Vested Right Claim
~~WATER PERMIT~~ NO. 1461-1

VESTED RIGHT WATER LICENSE NO. 1461-1

This letter is in response to a vested right claim being made for Martian dam located in Corson County, South Dakota. The following information is needed concerning the dam to complete the vested right claim:

Review of Contents of Plans & Specifications

SHEET 1

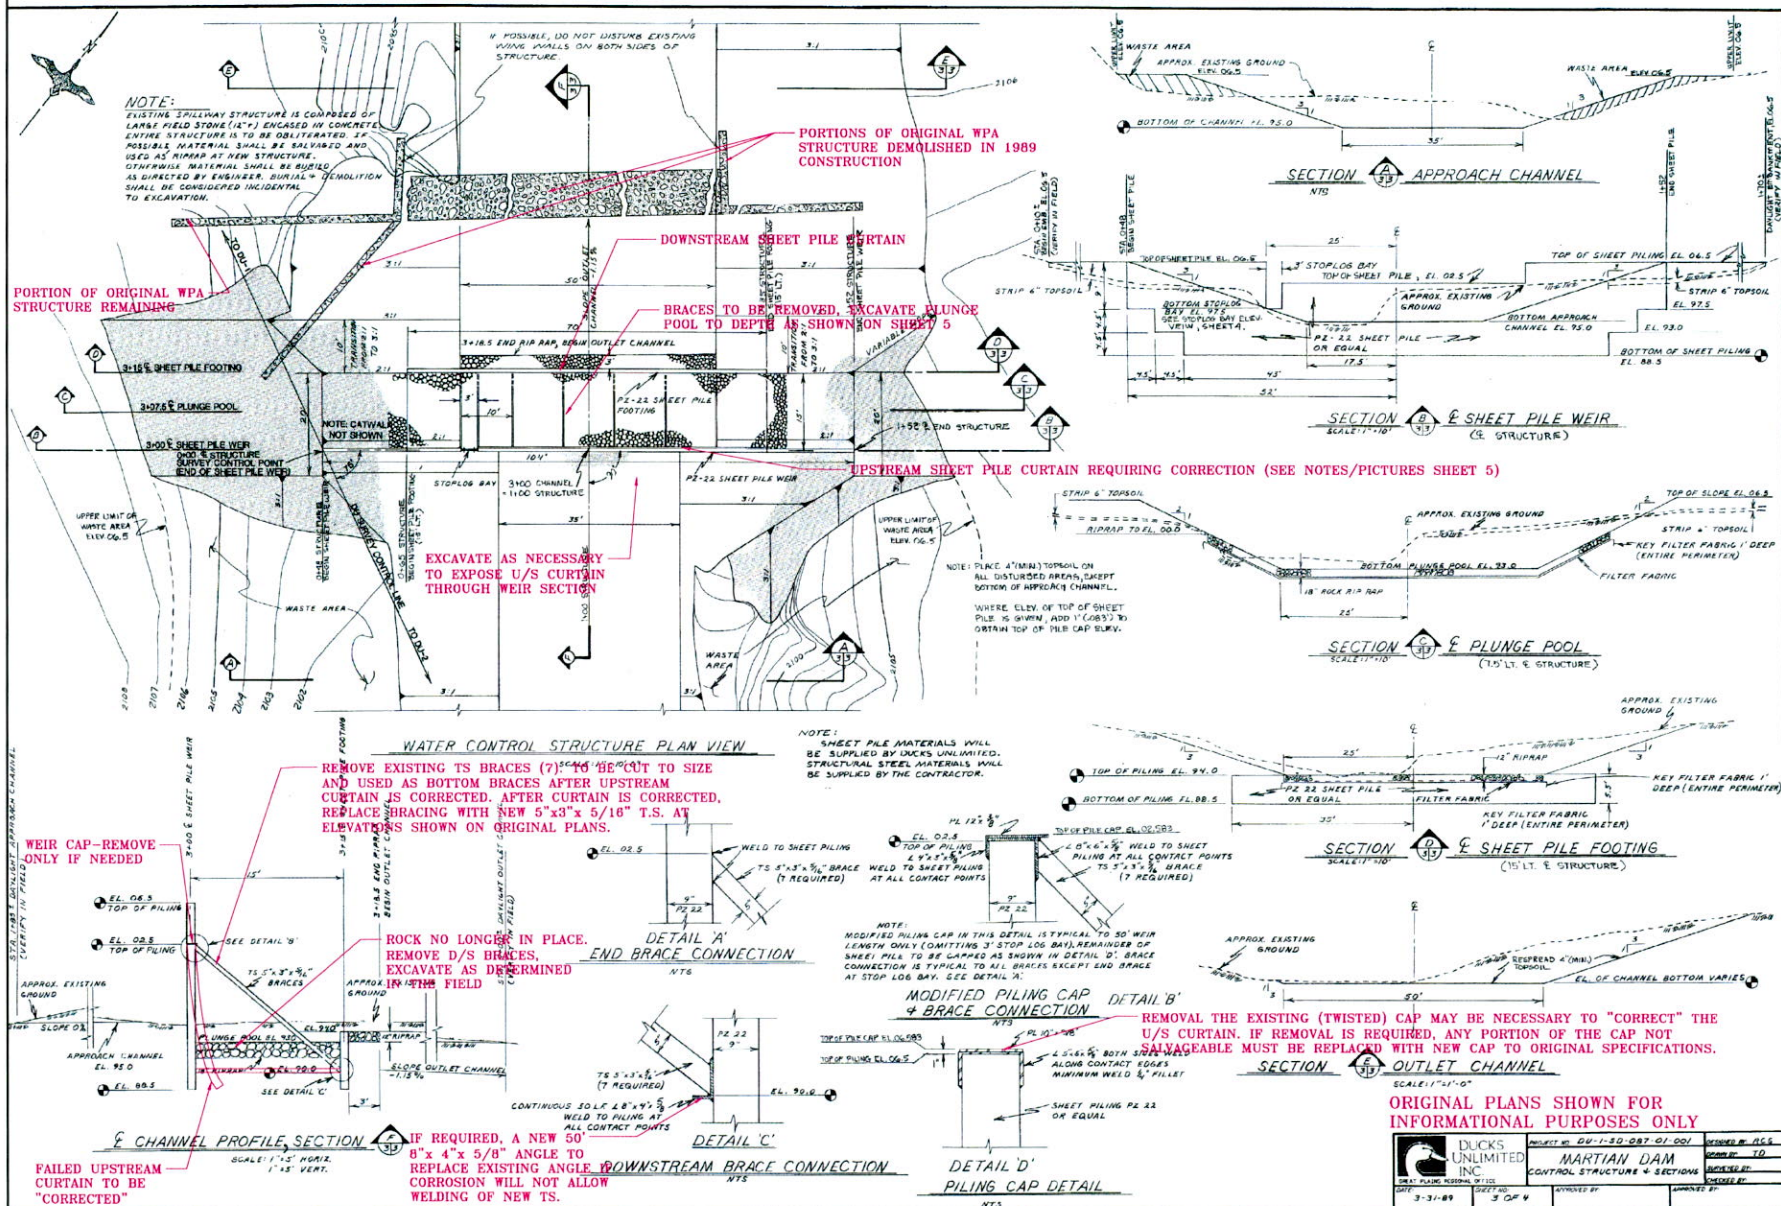
The spillway consisted of a sheet pile weir with a second sheet pile curtain driven downstream that acted like a footing to resist overturn. We were restricted to a shallow embedment depth due the presence of a dense layer sandstone. The downstream curtain also created a plunge pool, where we placed riprap. We were unaware that the original rock riprap had been displaced over the years. The loss of rock in the plunge pool allowed scour to develop to an elevation where there was no support to the toe of the upstream curtain. Piping below the upstream curtain

We plan to repair the structure and restore its function. I am unsure as to what permits might be required from DENR. Attached is a set of plans that will more clearly show how we plan to repair the structure.

USE OF FLOWABLE FILL CONCRETE TO REDUCING PIPING THREAT AND RESIST MOVEMENT IN "CORRECTED" WEIR WALL: THE ACTUAL ACTUAL LINES AND GRADES OF THE FLOWABLE FILL WILL BE DETERMINED IN THE FIELD AFTER CORRECTION IS APPLIED TO THE WEIR WALL.

Thank you for sending us the plan sheets for the repair of the Martian Dam, located in Section 14-T18N-R26E in Corson County. This dam is authorized under Vested Right Claim No. 1461-1, which was validated on September 28, 1989 for 123 ac-ft. of storage. After reviewing the plan sheets, I think we will classify the proposed repair work as "maintenance" and approval of the plans will not be required. However, I do agree with the proposed plan to correct the erosion and damaged sheet pile weir.

PROJECT NO. DU-1-SD-087-01-001	DESIGNED BY: R.C.S.
	MARTIAN DAM	DRAWN BY: T.D.
GREAT PLAINS REGIONAL OFFICE	CONTROL STRUCTURE & SECTIONS	SURVEYED BY:
DATE: 3-31-89	SHEET NO. 3 OF 4	CHECKED BY:
	APPROVED BY:	APPROVED BY:

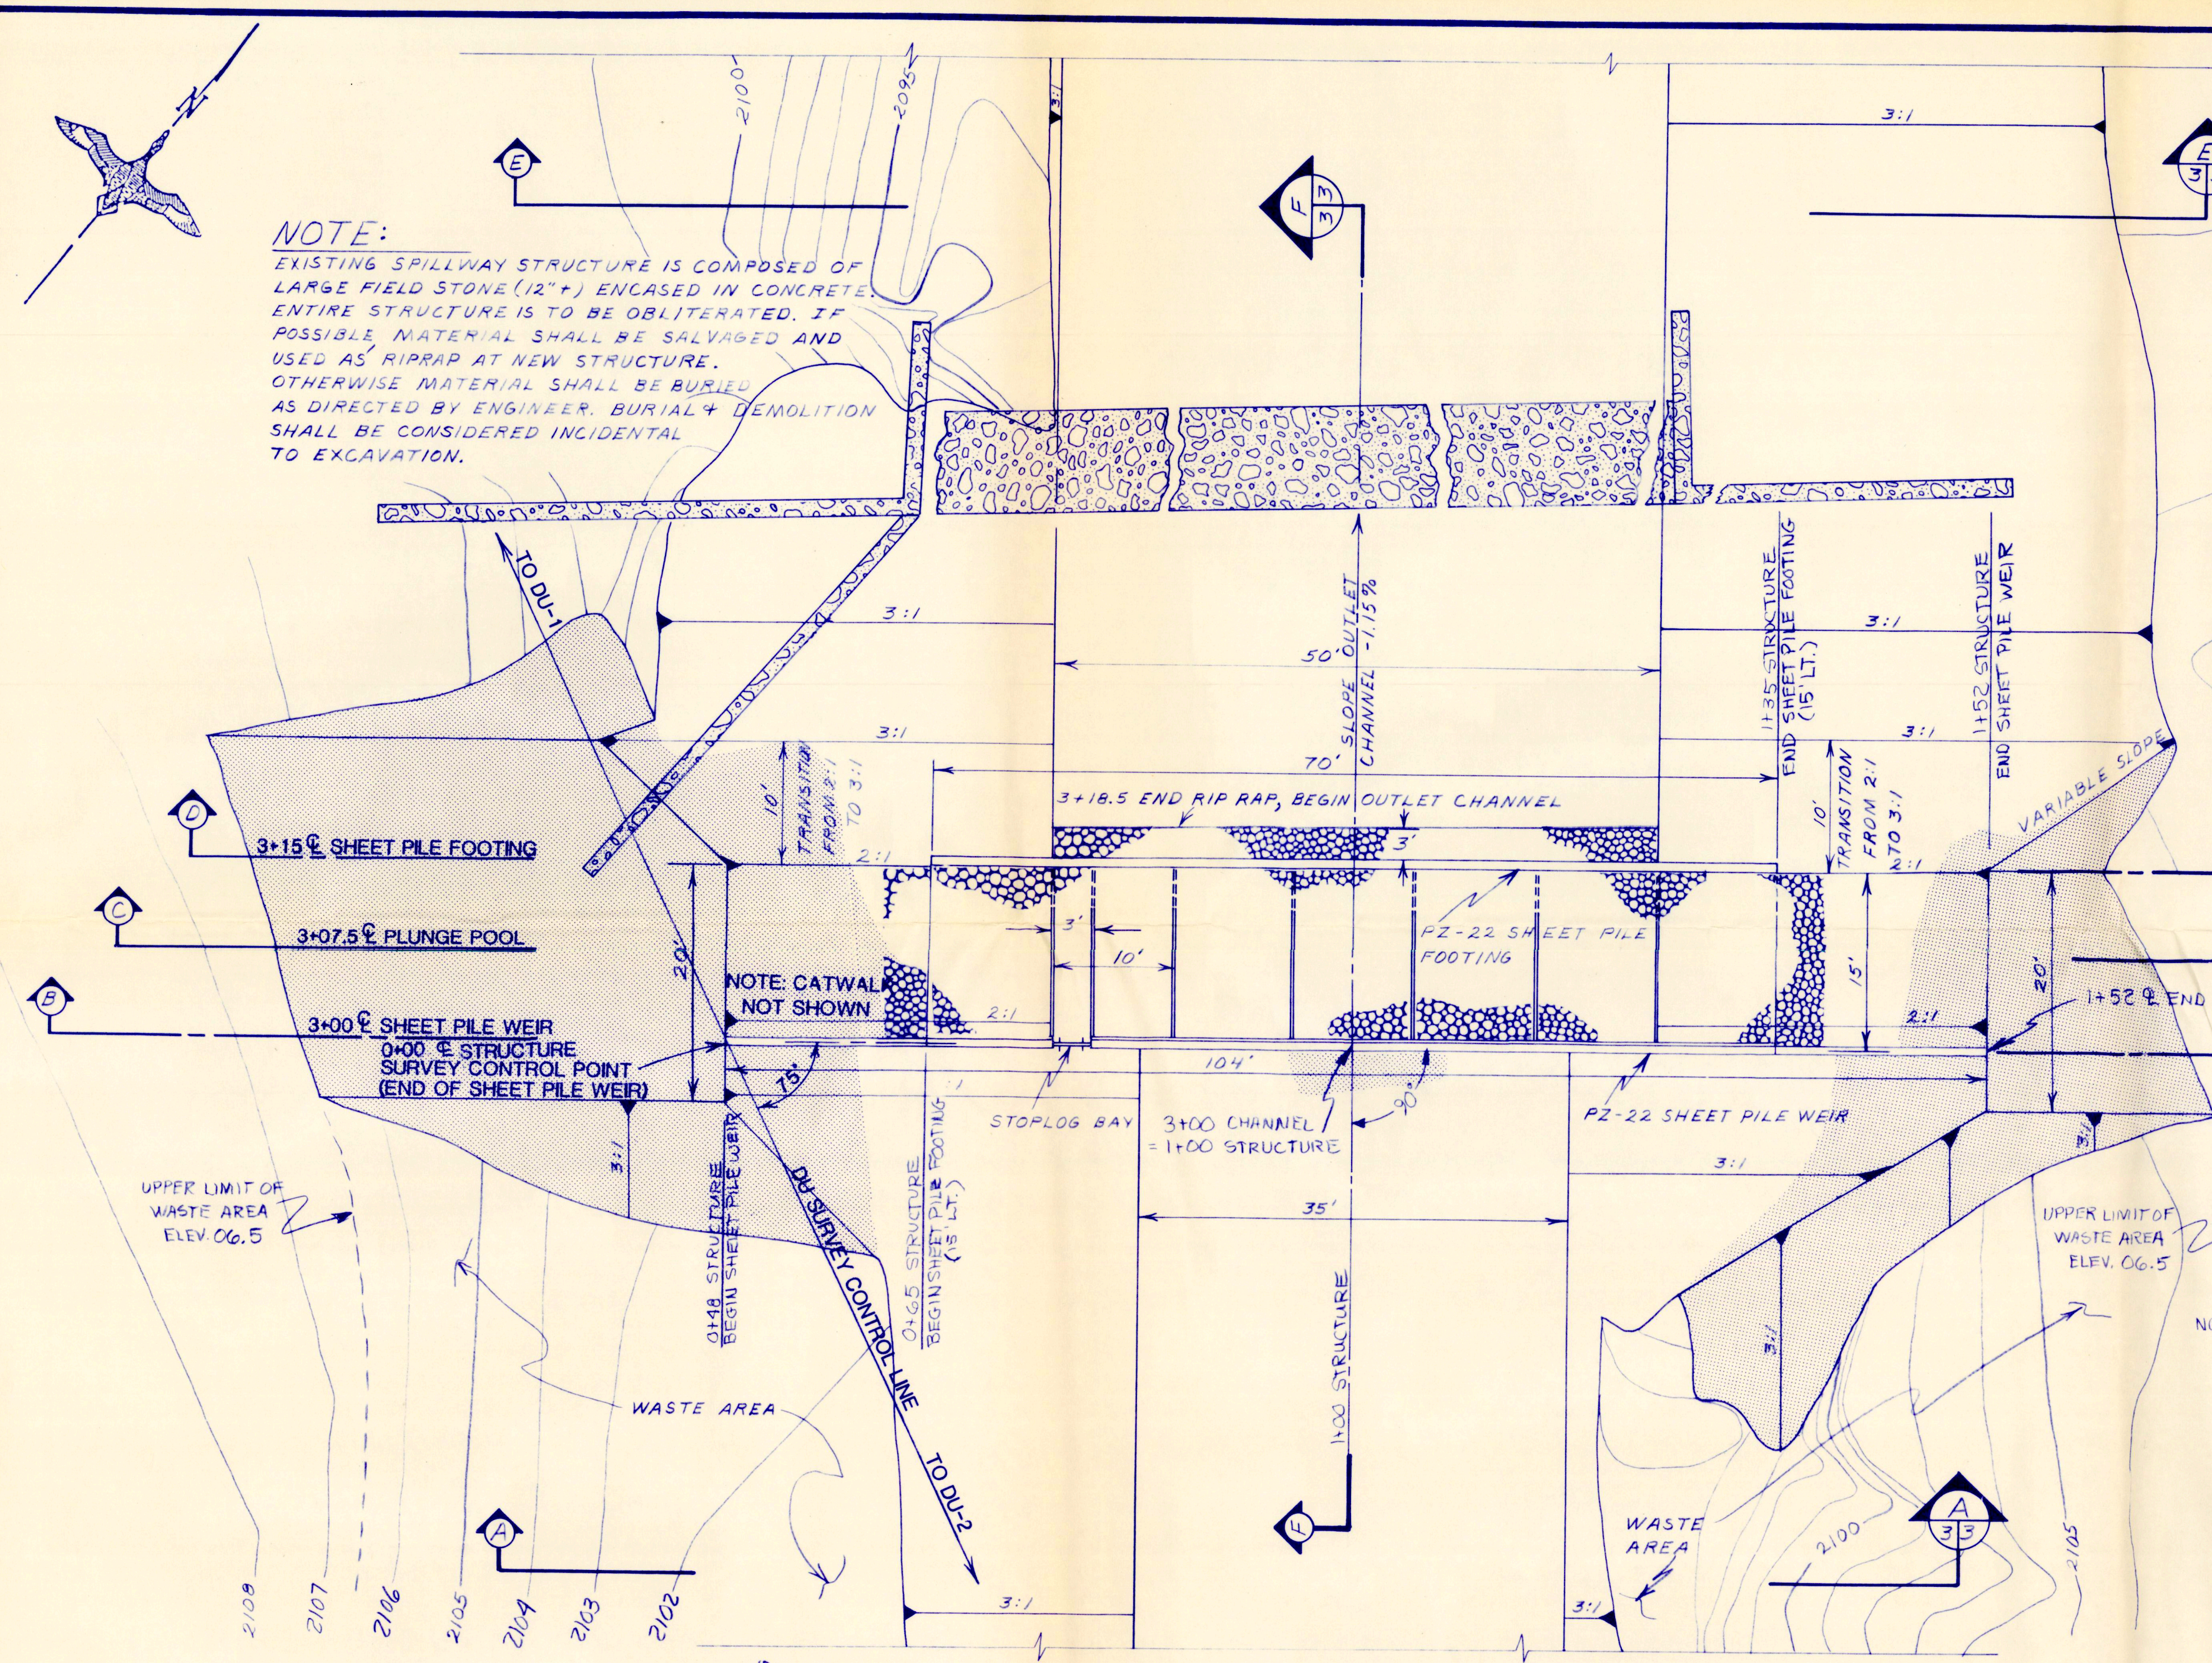
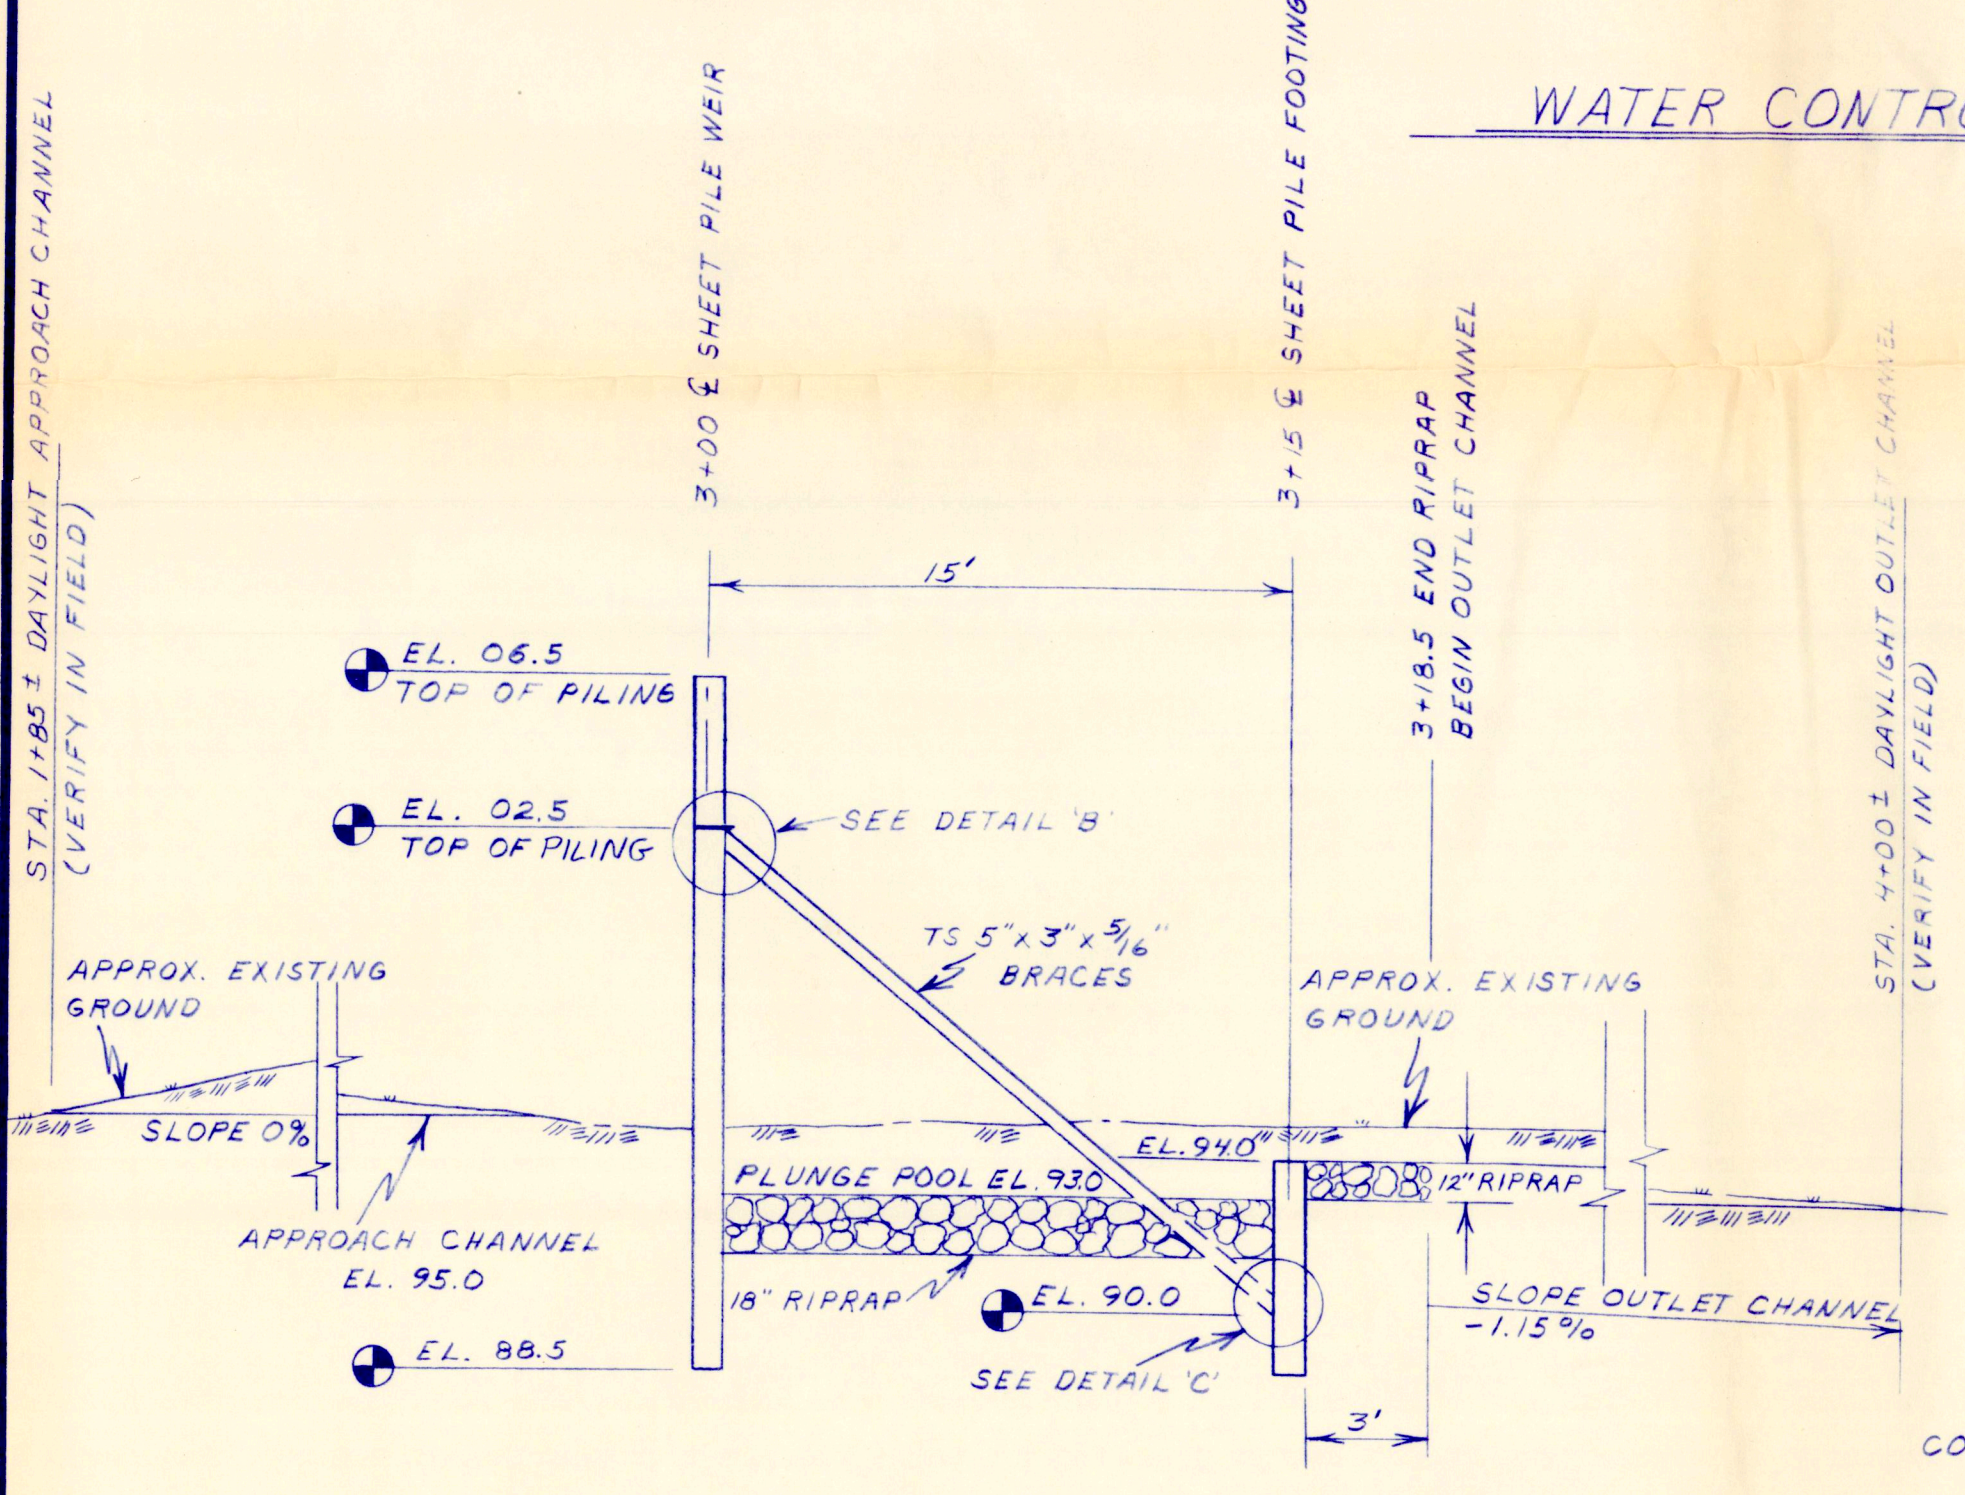
- 1) The enclosed plans and specifications need to be signed and stamped by a South Dakota registered professional engineer.
- 2) A written preliminary risk assessment of the downstream hazard potential needs to be provided to aid in determining the hazard classification for the dam (see enclosed Safety of Dams Rules Section 74:02:08:05). The hazard classification of the dam (Category 1, 2 or 3) is needed to determine what provisions of the Safety of Dams Rules will apply to your dam.

- 1) Topo map submitted? yes
- 2) Profile along dam axis & borehole locations? yes
- 3) Maximum cross section of dam? yes
- 4) Area - Capacity curves? yes but could be extended
- 5) Detailed drawings? yes
- 6) Q capacity of spillway? yes
- 7) Detailed plans of spillway? yes
- 8) Specifications? yes
- 9) EPP? not needed as determined from preliminary risk assessment

- 1) Construction plans and specifications signed by myself, a professional engineer registered in South Dakota.
- 2) A preliminary risk assessment.
- 3) A Design Report.
